Access Compliance Report

Public Rights-of-Way

Intersection ID: 43362	Main Street: PROSPERITY_VIEW_DR	Cross Street: RIDGE_RD	Location: NW
ADA ID: B7D332994D92	Ramp Type: Perp	Initial Pass/Fail: Fail	Overall Compliance: No
Severity Score: 8.75			
Codes/Mitigation Info/Possible Solution		Field Measurements/Component Compliance

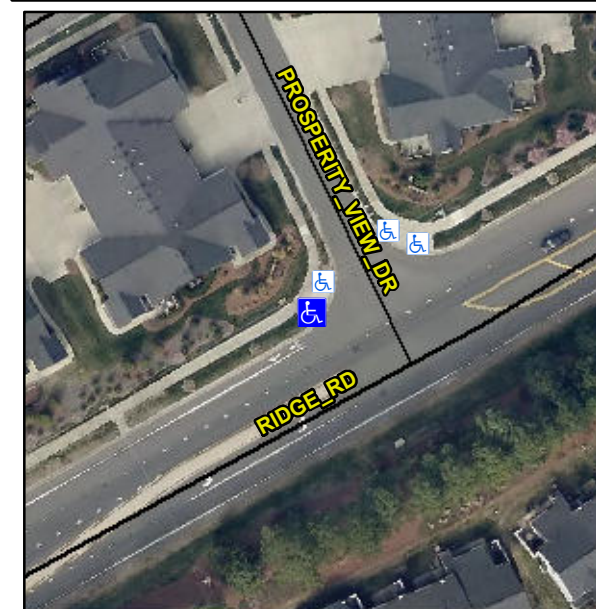
Remove & Replace Entire Ramp.

R304.5.1

Compliance	Description	Data	Compliance	Description	Data
N/A	Ramp Length (in)	109.0	Yes	Ramp Slope (%)	6.4
No	Ramp Width (in)	47.0	Yes	Ramp XSlope (%)	0.1
N/A	Flare Type LT	N/A	N/A	Flare Type RT	N/A
N/A	Flare Slope LT (%)	N/A	N/A	Flare Slope RT (%)	N/A
N/A	Flare Traversable LT?	N/A	N/A	Flare Traversable RT?	N/A
N/A	Landing Length (in)	N/A	N/A	DWS Provided?	N/A
N/A	Landing Width (in)	N/A	N/A	DWS Contrast?	N/A
N/A	Landing Slope (%)	N/A	N/A	DWS Length (in)	N/A
N/A	Landing X Slope (%)	N/A	N/A	DWS Full Width?	N/A
N/A	Landing Curb? (Y/N)	N/A	N/A	DWS Offset (in)	N/A
N/A	Shared Landing?	N/A			
N/A	Gutter Ponding?	N/A	N/A	Gutter Slope (%)	N/A
N/A	Gutter Lip Ht (in)	N/A	N/A	Gutter X Slope (%)	N/A
N/A	Painted X Walk1?	No	N/A	Painted X Walk2?	N/A
	X Walk 1 Direction	To S		X Walk 2 Direction	N/A
N/A	X Walk 1 Width (in)	N/A	N/A	X Walk 2 Width (in)	N/A
	X Walk 1 Slope (%)	0.7		X Walk 2 Slope (%)	N/A
	X Walk 1 X Slope (%)	1.6		X Walk 2 X Slope (%)	N/A
